Wisconsin Department of Transportation

**Proposal #11: 1030-20-85, WISC 2017 485
N-S Freeway - Ryan Road
Interchange
Ryan Rd, Bridge & Ramps
IH 94
Milwaukee County**

**1030-26-72
North-South Freeway
Ryan Road to Rawson Avenue
(Box Culvert Extensions)
IH 94
Milwaukee County**

This is Addendum No. 03, which provides for the following:

Addendum No. 03
 ID 1030-20-85
 Revised Sheet 869
 September 7, 2017

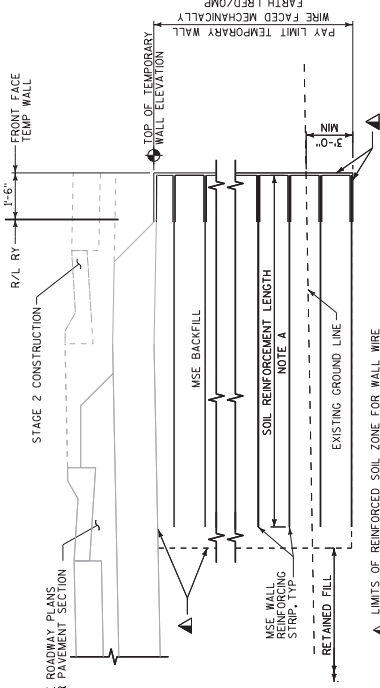
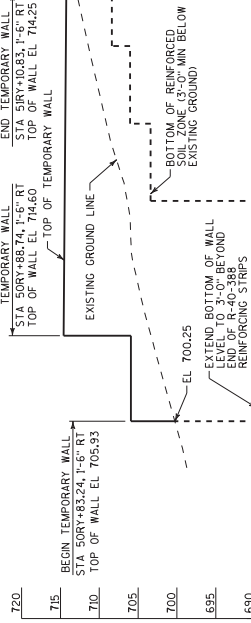
Revised Plan Sheets	
Plan Sheet	Plan Sheet Title (brief description of changes to sheet)
456	Removed incorrect note from Earthwork Notes
482	Displayed hidden columns on Pavement Marking Items table in Miscellaneous Quantities
869	Revised Fence Decorative Wing quantity in the Total Estimated Quantities Table
